NORTHEAST UTILITIES

November 15, 1985

Docket No. 50-423
B11874

Millstone Nuclear Power Station, Unit No. 3
Final Safety Analysis Report Changes

FIGURE 15.2-10B
CORE AVERAGE TEMPERATURE TRANSIENT
AND STEAM GENERATOR WATER VOLUME
TRANSIENT FOR LOSS OF NORMAL FEEDWATER
MILLSTONE NUCLEAR POWER STATION
UNIT 3
FINAL SAFETY ANALYSIS REPORT
Four Loop Operation

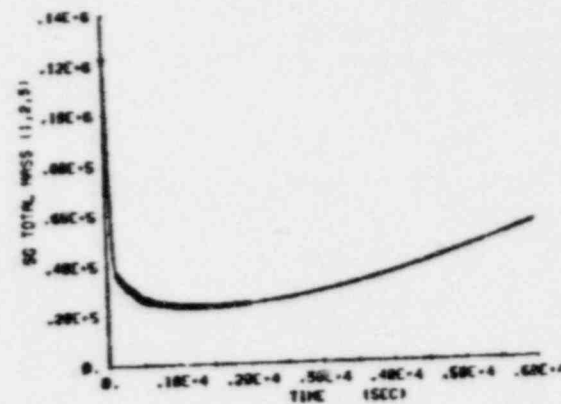
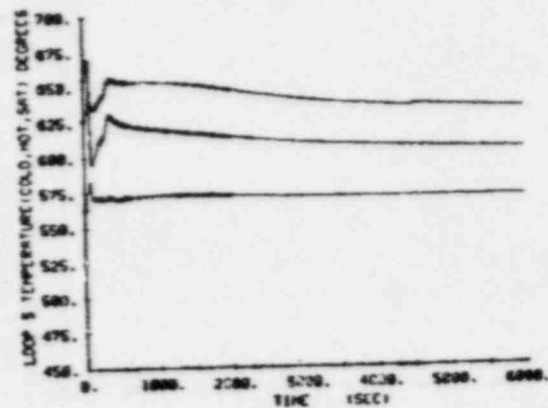
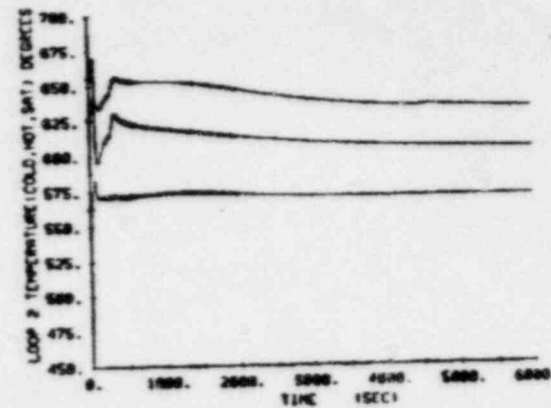
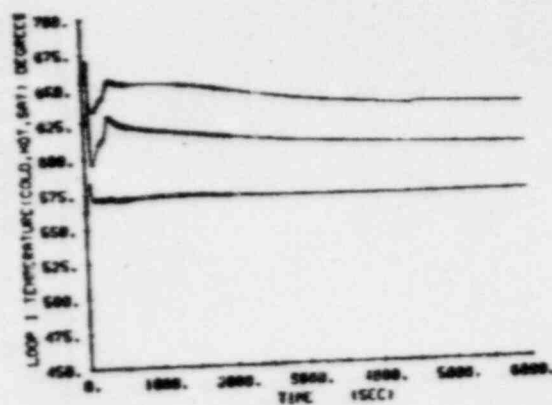
INSERT

WITH LOSS OF
OFFSITE POWER

Figures 15.2.9B and 15.2.10B are for four loops in operation initially with a loss of offsite power.

FIGURE 15.2-9
PRESSURIZER PRESSURE AND
WATER VOLUME TRANSIENTS
FOR LOSS OF NORMAL FEEDWATER
MILLSTONE NUCLEAR POWER STATION
UNIT 3
FINAL SAFETY ANALYSIS REPORT

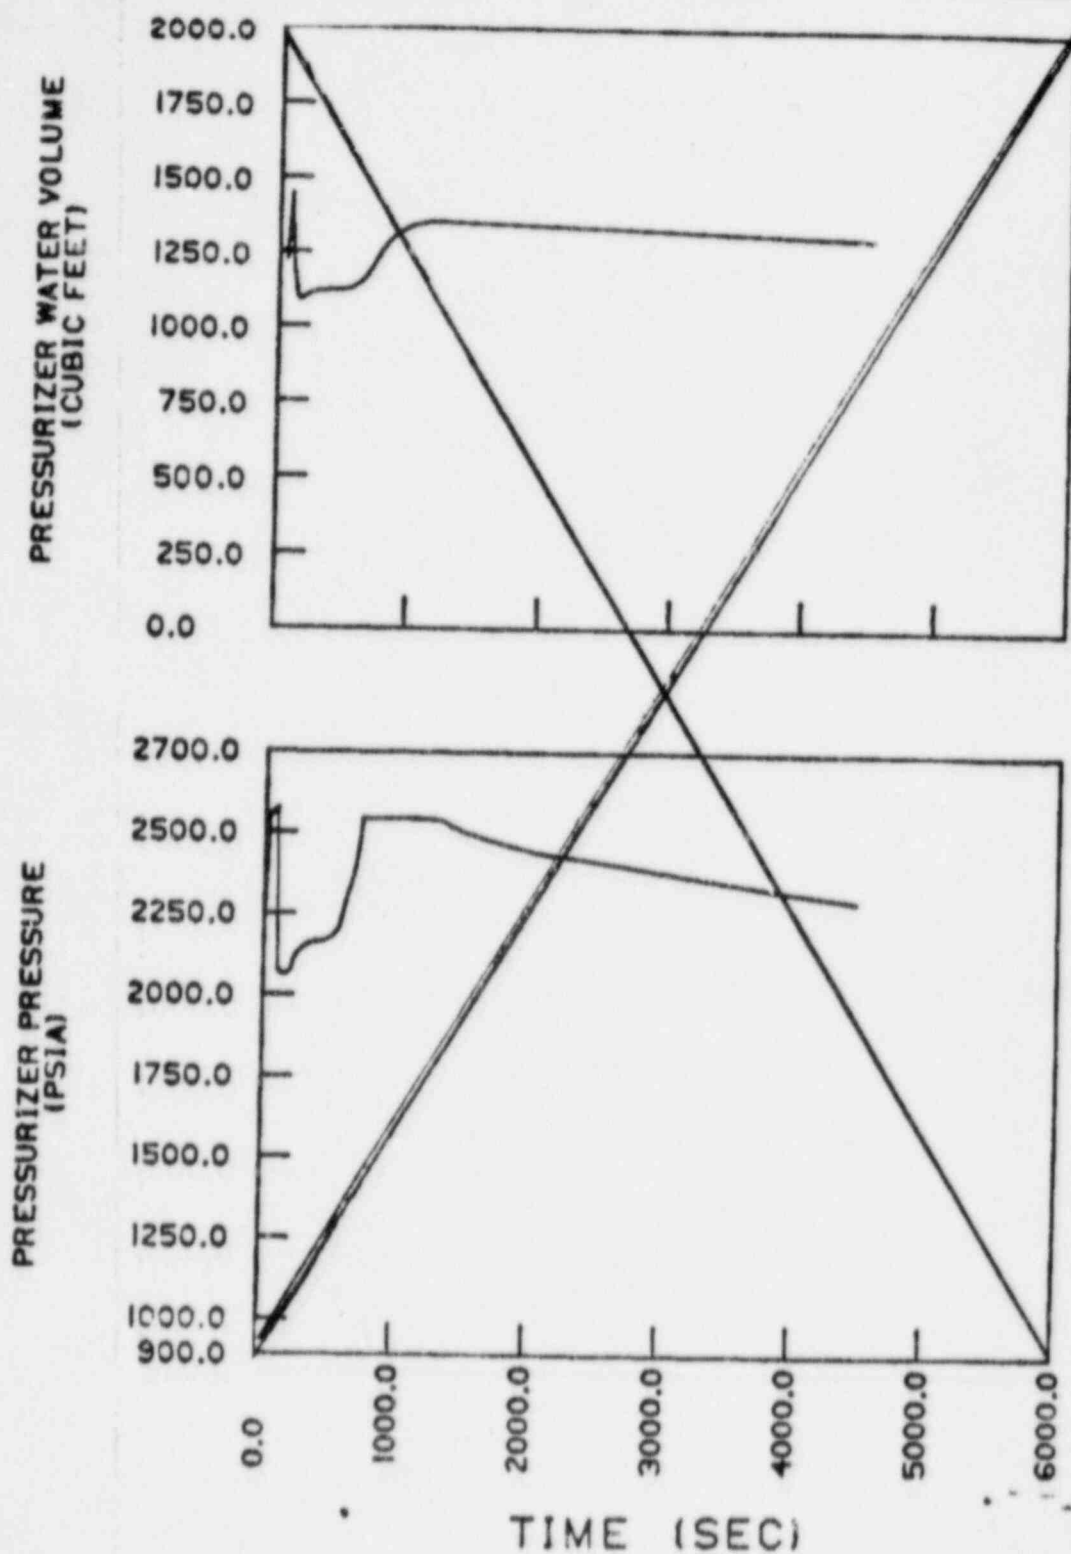
12 | Figures 15.2-9 and 15.2-10 show the significant plant parameter transients following a loss of normal feedwater with four loops in operation initially. Figures 15.2-9A and 15.2-10A are for three loops in operation initially. ,

The calculated sequence of events for this accident is listed in Table 15.2-1. As shown on Figures 15.2-9, ~~and~~ 15.2-10, the plant approaches a stabilized condition following reactor trip and auxiliary feedwater initiation. Standard plant shutdown procedures may be followed to further cool down the plant.

15.2.9A^B and 16.2.10A^B

FIGURE 15.2-10
 CORE AVERAGE TEMPERATURE TRANSIENT
 AND STEAM GENERATOR WATER VOLUME
 TRANSIENT FOR LOSS OF NORMAL FEEDWATER
 MILLSTONE NUCLEAR POWER STATION
 UNIT 3
 FINAL SAFETY ANALYSIS REPORT

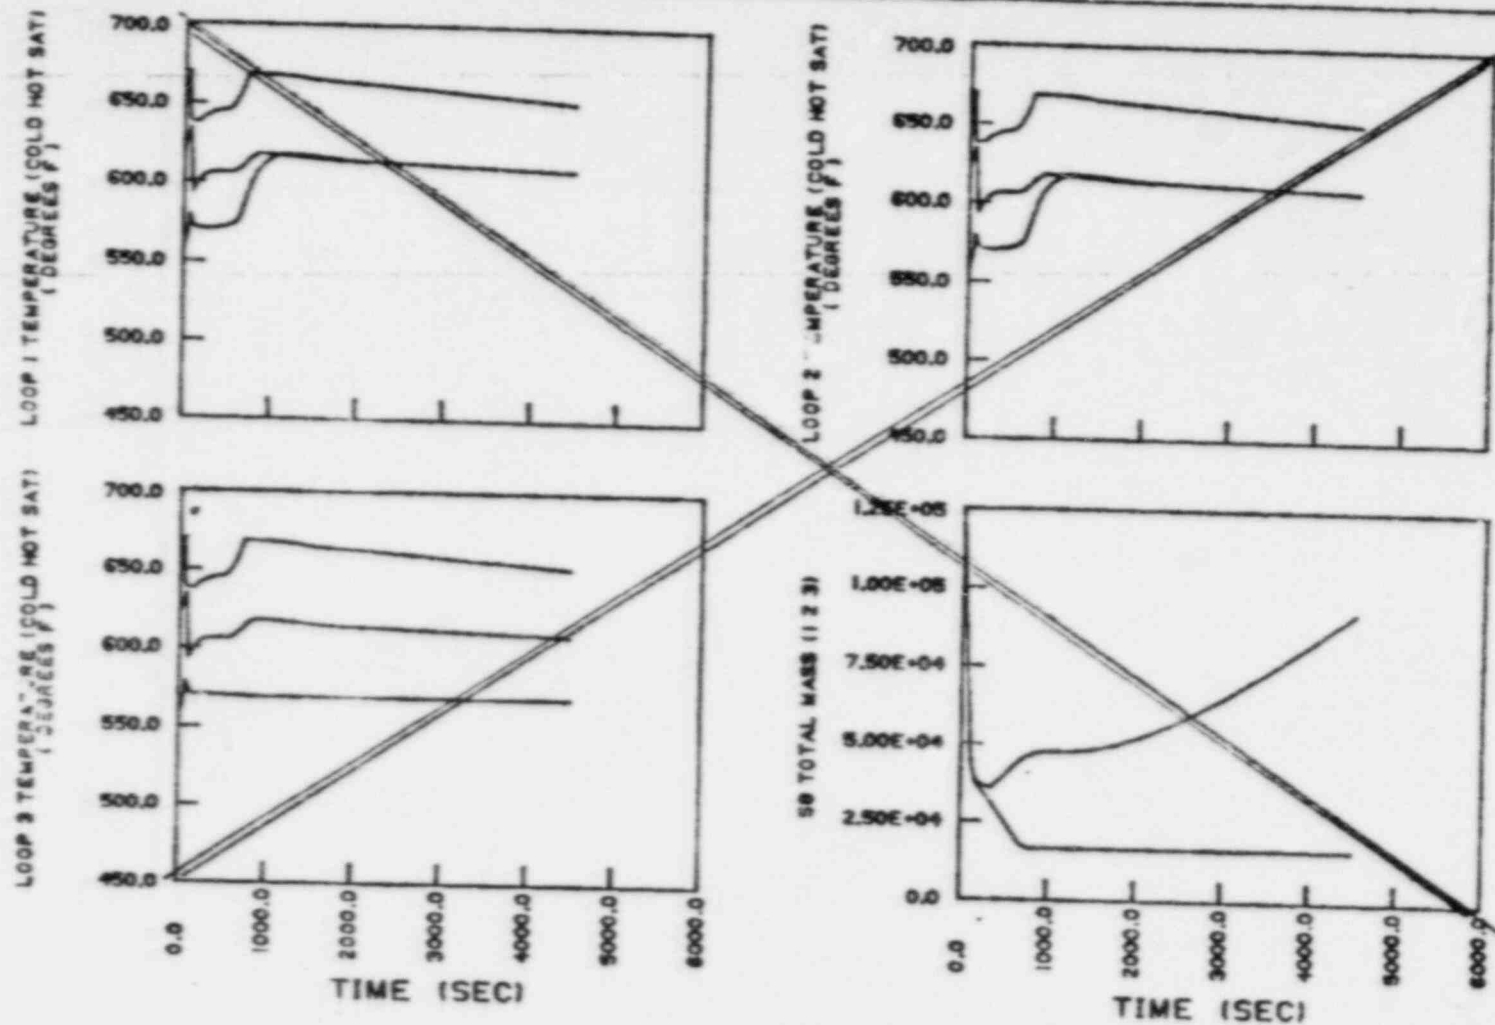
The capacity of the auxiliary feedwater pumps is such that the water level in the steam generator being fed does not recede below the lowest level at which sufficient heat transfer area is available to dissipate core residual heat without water relief from the RCS relief or safety valves. From Figure 15.2-10 it can be seen that at no time

↑ 15.2-10A, and 10B,

FIGURE 15.2-98
PRESSURIZER PRESSURE AND
WATER VOLUME TRANSIENTS
FOR LOSS OF NORMAL FEEDWATER
MILLSTONE NUCLEAR POWER STATION
UNIT 3
FINAL SAFETY ANALYSIS REPORT
Four Loop Operation

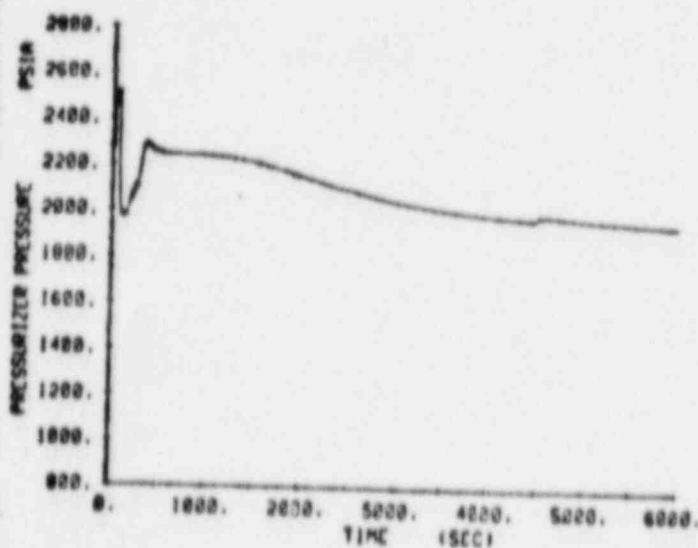
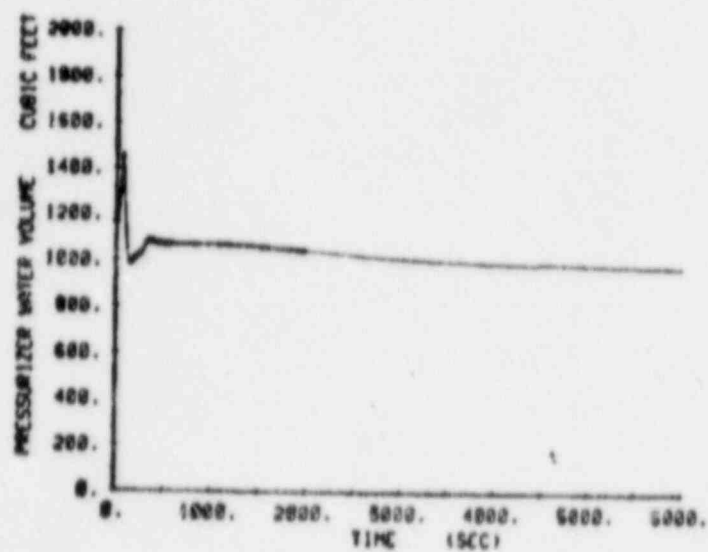
WITH LOSS OF
OFFSITE POWER
